CONTRACT CHANGE ORDER

CCO: 26 Suppl. No. 0 Contract No. 04 - 0120F4 Road SF-80-13.2/13.9 FED. AID LOC.:

- Eliminates contract Item #102, "WIND VORTEX GENERATOR PLATES," and revises Section 10-1.85, "WIND VORTEX GENERATOR PLATES" of the Special Provisions, to address the material change from Acrylic Plexiglas G to 13 mm steel plates, storage, and installation.
- Provides for cleaning and painting wind vortex generator plates, in accordance with Section 10-1.69 "CLEAN AND PAINT STRUCTURAL STEEL" of the Special Provisions.
- Revises contract plan sheets 874 and 875 (of 1204) as shown on sheets four through five of this change order to address changes.
- Resolves costs associated with Contractor Request For Change (RFC) No. 13R1 with respect to changes listed above are resolved by this change order.

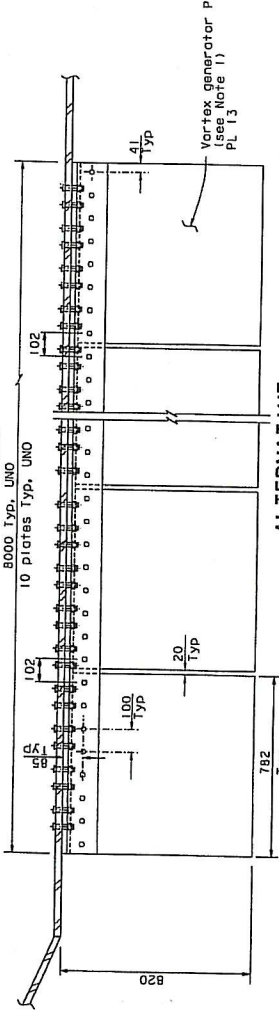
For the change in character to supply and store the 13 mm steel plating in lieu of Acrylic Plexiglas G plates, and for erecting the wind vortex generator plates as shown on revised plan sheets 874R1 and 875R4, the Contractor agrees to accept the sum of \$1,738,000.00. This sum constitutes full and complete compensation for furnishing all labor, material, tools and incidentals including all markups, all direct and indirect costs, all overhead expenses, and all associated project impacts by reason of installing these plates.
